TO: Mercedes-Benz Dealer Principals, General Managers, Sales Managers, Service Managers, Parts Managers	FROM: Thomas Brunner, Department Manager, Vehicle Compliance and Analysis, Engineering Services
RE: Recall Campaign 2013110009- Front Passenger Seat Occupant Classification System. Model 231 (SL). Model Year 2013	DATE: December 20, 2013

Campaign No. 2013110009, December 2013

SUBJECT: **Model 231 (SL Class), Model Year 2013**
Replace Front Passenger Seat Occupant Classification System

Figure 1

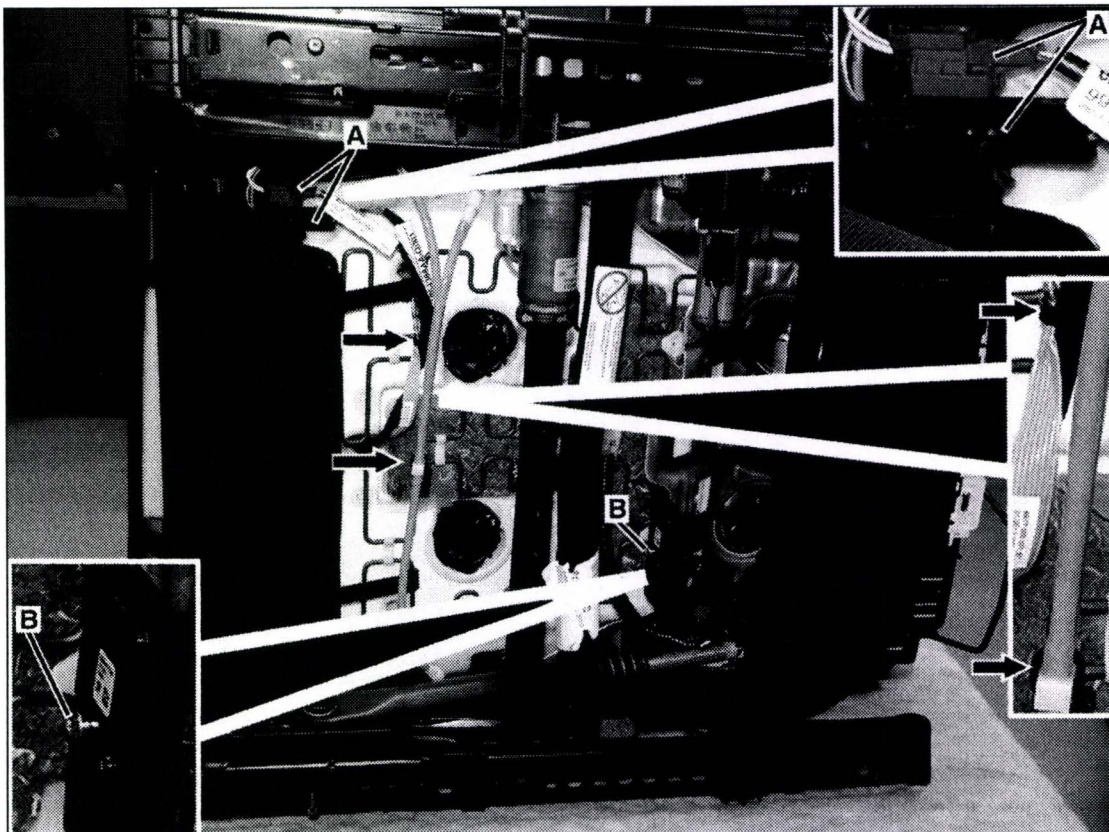
- Cover the right door sill and door weather stripping to protect it when removing seat.
- Replace 2 cable ties (arrows, Figure 1).
- Location and amount of cable ties (arrows) may vary according to equipment.
- Disconnect harness connectors (A).
- Remove bolt (B) for weight sensing system sensor.
